HADAS

24/00959/FUL: Erection of 5no. houses with associated landscaping and car parking following demolition of existing garages

Land adjacent to Rochdale Road at Hillbank and Church Avenue,
Middleton

Introduction / Background

Hillbank Street:

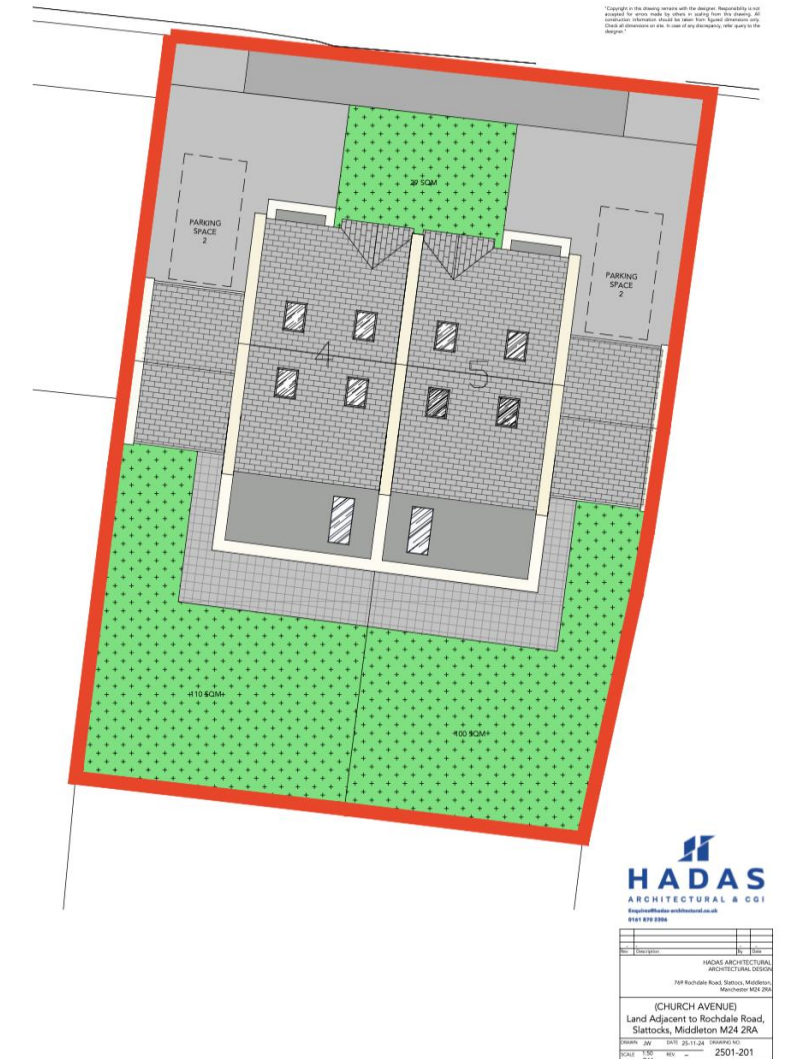
Hillbank Street has had significant changes to overcome issues such as right of ways and overdevelopment concerns. As such, the proposed scheme has repositioned the development on the site and removed 1no dwelling. By providing the access road to the allotments at the rear, the new proposal will have an inviting street scene from both the newly proposed street and Rochdale Road. Hillbank Street has also had basements and 1 No Bedroom removed following overdevelopment concerns. A sun path analysis has been conducted to ensure that sunlight is no restricted to any of the existing houses and their gardens.
